Written Comment on the Draft Environmental Impact Report

SCE Ivanpah-Control Project

Application A.19-07-015 · State Clearinghouse #2020080553

Crater Mountain Realignment Alternative · 945 Birch Creek Road, Big Pine, CA

EXHIBIT 1

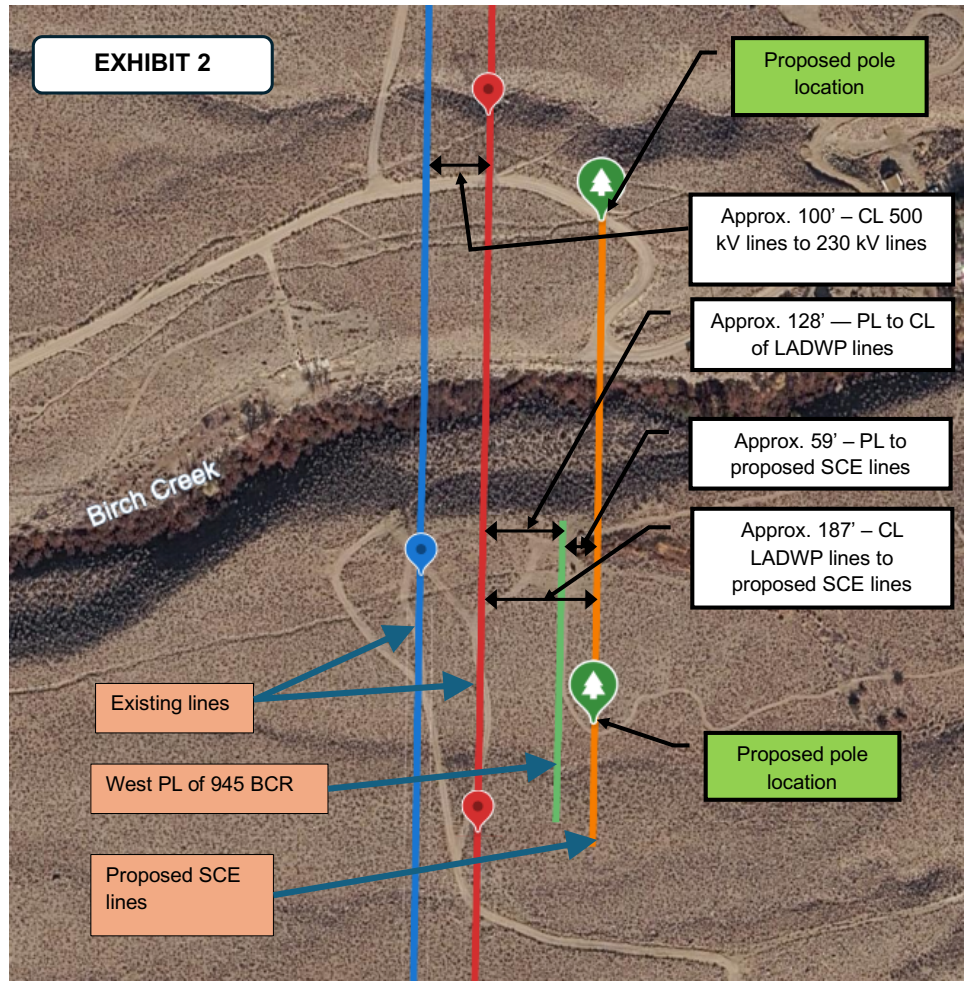
My parcel at 945 Birch Creek Road sits within this Direct API. SCE conducted a cultural resources survey on the parcel during prior project development, identifying artifacts including pottery, a millstone, arrowheads, and an extensive obsidian working area. A round house foundation is also present on the property. These are documented cultural resources on a residential parcel where the Crater Mountain Realignment Alternative would site Structure 26.

Second, that the Final EIR include site-level analysis of how Structure 26 placement on this parcel would interact with the documented cultural resources, including the round house foundation and the extensive obsidian working area extending across the western edge of the parcel and onto adjacent land beneath the existing LADWP corridor.

(See Exhibit 1 for SCE-provided map showing the Structure 26 work area on the parcel.)

Measurement approximations made using Google Earth. Distance between the centerline (CL) of the LADWP line and the western property line (PL) of the 945 Birch Creek Road parcel was confirmed onsite using a tape measure (by Terry Cavanagh and Coral Cavanagh, April 24, 2026).

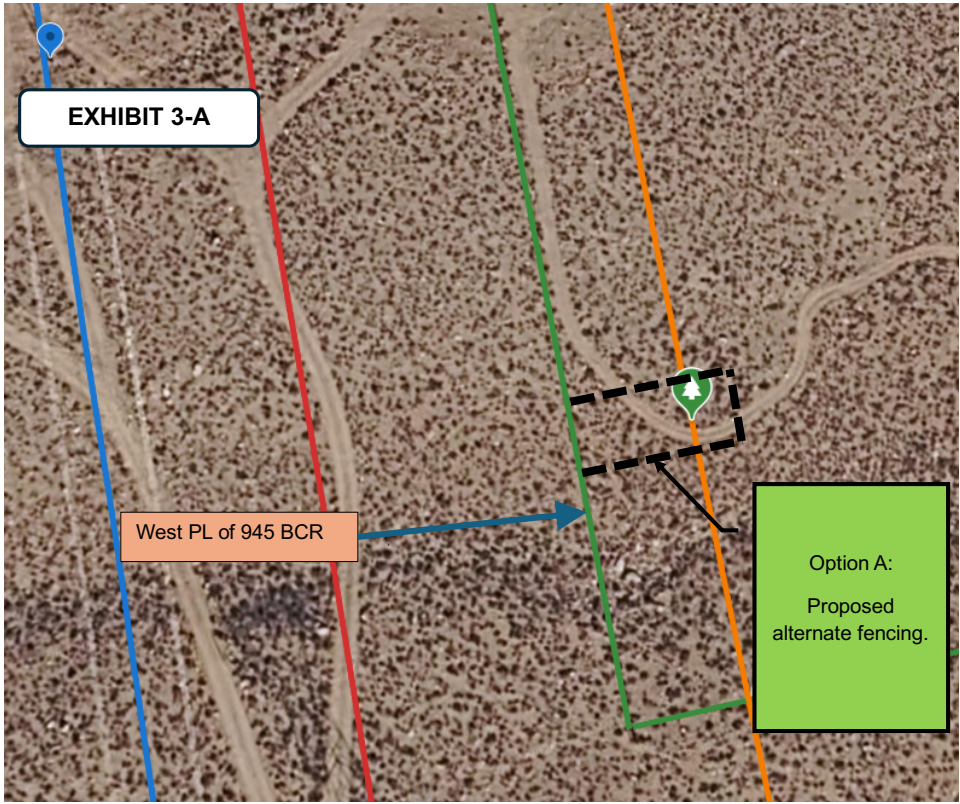
A specific factual matter bears on the analysis. The 200-foot separation described in Section 4.3.1.1 (page 4-5) is the assumed distance between the proposed new SCE structures and the eastern LADWP structures. However, the distance from the LADWP corridor to the western edge of the 945 Birch Creek Road parcel is itself disputed. SCE’s land acquisitions team has stated, based on GIS measurement, that the parcel is approximately 230 feet from the existing LADWP transmission line. Independent on-site measurement by tape from the LADWP transmission line centerline (which lies east of the Pacific DC Intertie) to the western property line of 945 Birch Creek Road yielded approximately 128 feet. The Draft EIR’s noise analysis (page 4-59) characterizes the Birch Creek residences as “approximately 250 feet east of the Crater Mountain Realignment Alternative.” A discrepancy of more than 100 feet between competing measurements is substantial when the alternative’s structure placement depends on it. The Final EIR should either resolve the discrepancy or analyze impacts under each measurement assumption.

For the Final EIR, I request that the description of the Crater Mountain Realignment Alternative acknowledge the Birch Creek Community by name, identify the number of private residential parcels potentially affected by the alternative, and reconcile the distance measurements between the LADWP corridor and the affected parcels through licensed survey. (See Exhibit 2 for measurement documentation.)

(See Exhibit 2 for measurements of distances between the existing LADWP corridor, the proposed alternative alignment, and residential parcels on Birch Creek Road.)

EXHIBIT 3-B

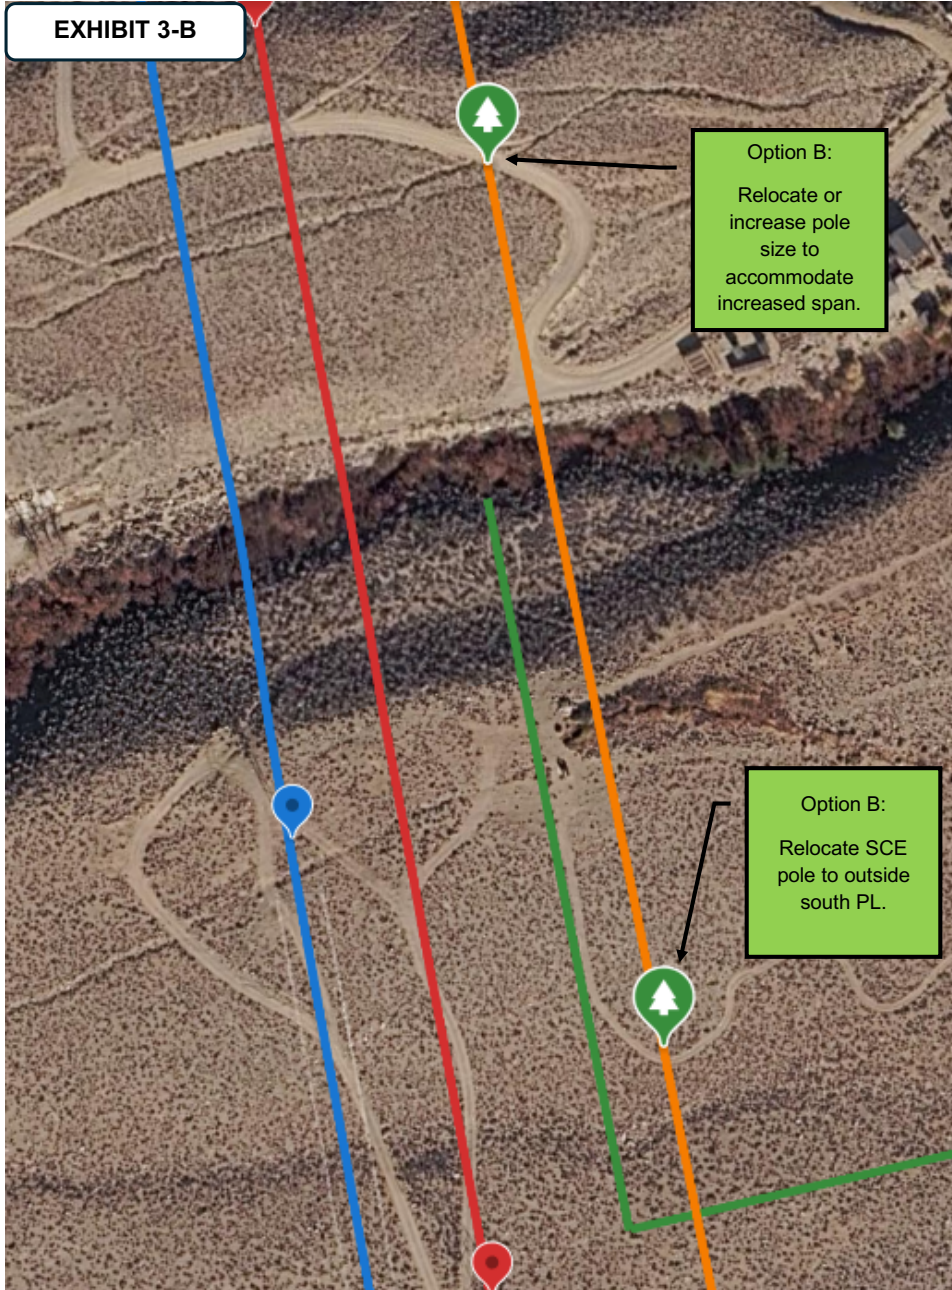
Option B — Replacement-pole configurations between Structures 25 and 27. The single preliminarily sited Structure 26 would be replaced with the minimum number of additional structures necessary to avoid any placement of structures on the 945 Birch Creek Road parcel and at sufficient distance from the residence adjacent to preliminarily sited Structure 25 at 1365 Birch Creek Road. The 1,500-foot run between Structures 25 and 27 would be split into shorter spans, all satisfying the 750-foot maximum span constraint. The engineering team should evaluate first whether a two-pole replacement can satisfy both constraints, and only if it cannot, whether a three-pole replacement can. The goal would be to keep the modification contained between Structures 25 and 27 with no cascade effect on the siting of any other structures. (See conceptual drawing in Exhibit 3-B.)

Option B:
Relocate or
increase pole
size to
accommodate
increased span.

Option B:
Relocate SCE
pole to outside
south PL.

spacing requirements and conductor swing under wind conditions. On Option B, SCE characterized the replacement-pole configuration as unlikely to be feasible: the parcel width is approximately 692 feet, achieving spans that keep all structures off the parcel would require pushing onto adjacent parcels with a total span approaching 800 feet, and the practical maximum span for this voltage and structure type is below 750 feet. An additional pole between Structures 25 and 27 would necessarily be sited on the adjacent residential parcel at 1365 Birch Creek Road. On Option C, SCE acknowledged the configuration as technically feasible — SCE crosses LADWP-style corridors at multiple points in Southern California — but characterized it as impractical absent Commission direction. SCE indicated that if the Commission directs Option C as a project modification, SCE would implement it; absent such direction, SCE would not adopt Option C on its own initiative. On Option D, SCE indicated that the LADWP-spacing constraint underlying the 200-foot offset has approximately 50 feet of available flexibility — DWP requested 150 to 200 feet of separation, and SCE used 200 feet (worst case). SCE noted, however, that even shifting the alignment 50 feet west would likely still result in the structure on or adjacent to the property line.

EXHIBIT 3-D

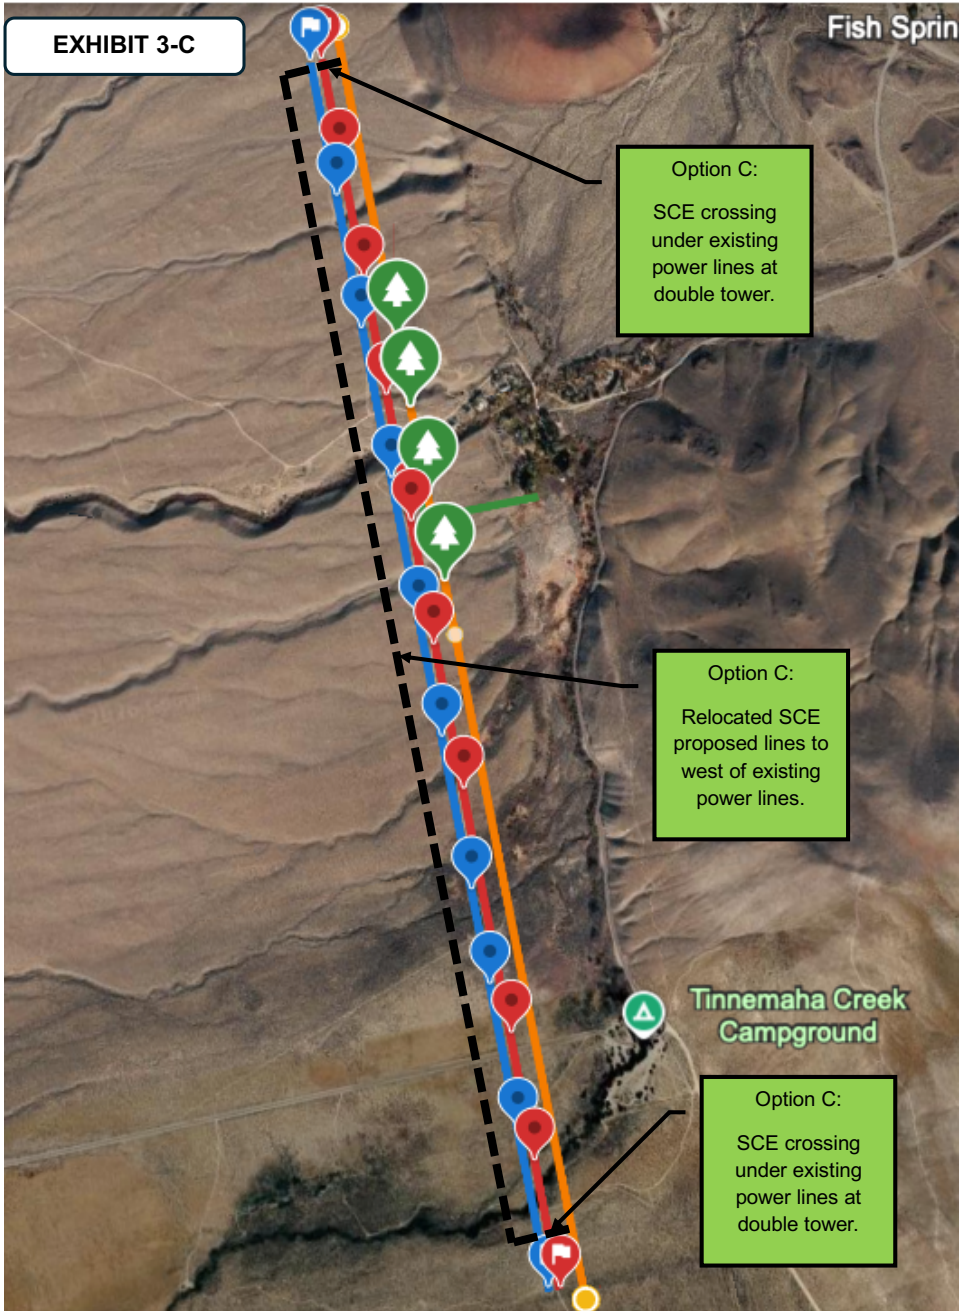
Option D — Local alignment between the LADWP corridor and the western edge of 945 Birch Creek Road. In the area adjacent to the Birch Creek Community, the new corridor would be aligned between the LADWP corridor and the western edge of 945 Birch Creek Road. On-site measurements suggest there may be sufficient room between the western property boundary and the LADWP corridor to accommodate a 75- to 100-foot-wide SCE corridor. This option would not require crossing the LADWP corridor, but would require a deviation from a strict 200-foot offset over a short distance relative to the entire Segment 1. This option could avoid crossing residential properties of the Birch Creek Community. (See conceptual drawing in Exhibit 3-D.)

- **Option D (local alignment between LADWP corridor and western edge of 945 Birch Creek Road).** SCE indicated that the LADWP-spacing constraint underlying the 200-foot offset has approximately 50 feet of available flexibility — DWP requested 150 to 200 feet of separation, and SCE used 200 feet (worst case). SCE noted, however, that even shifting the

alignment 50 feet west would likely still result in the structure on or adjacent to the property line.
